## HIGHCASTLE HOMES

PROJECT/LOCATION  
RIVERWALK, PHASE 2  
BRAMPTON, ON

## SITE PLAN

## SITE PLAN REVIEW

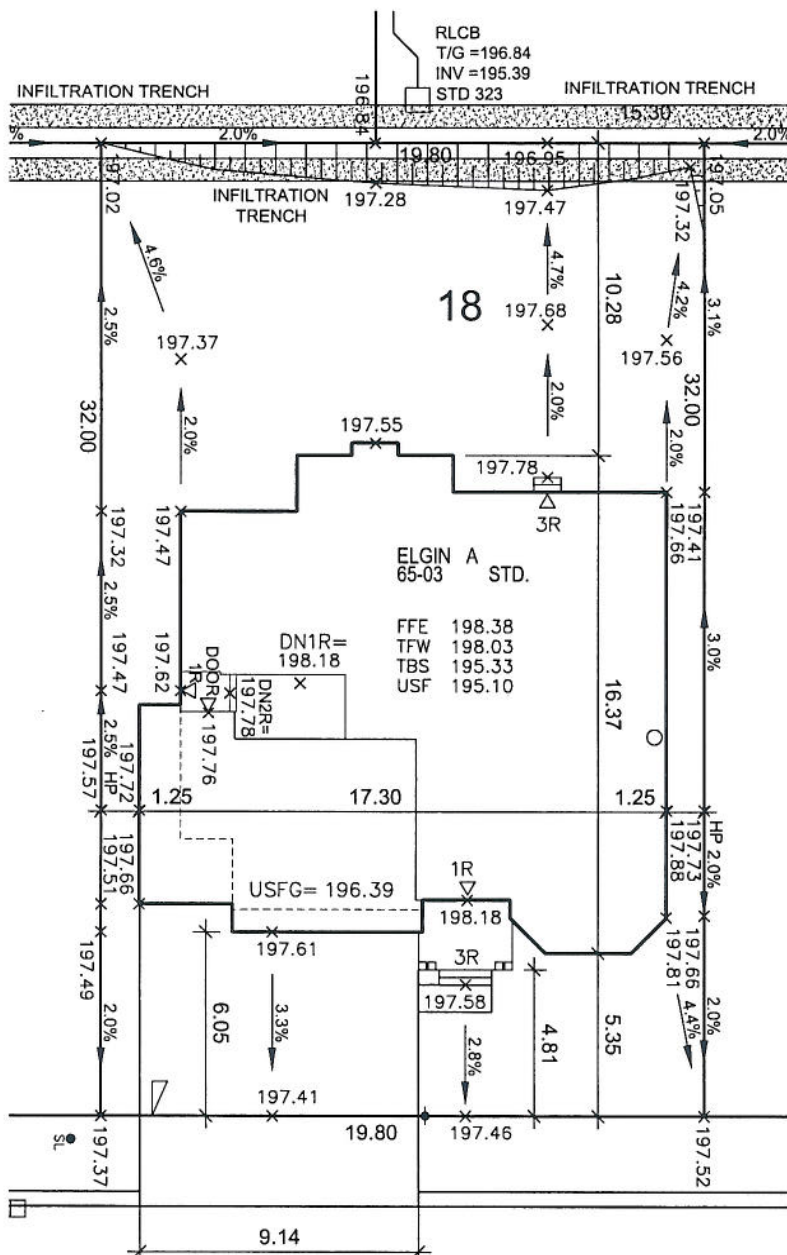
COMMENTS AS NOTED

RLCB LEAD PRESENT, CAUTION WHEN EXCAVATING.  
BUILDER TO VERIFY ADEQUACY OF FOUNDING SOILS  
ADJACENT TO RLCB LEADS.

SANITARY AND STORM INVERTS ARE NOT AVAILABLE  
AT THE TIME OF SITING; BUILDER TO VERIFY  
ELEVATIONS OF SANITARY AND STORM LATERALS IN  
RELATION TO BASEMENT USE ELEVATIONS FOR  
COMPLIANCE WITH MUNICIPAL STANDARDS PRIOR TO  
EXCAVATION
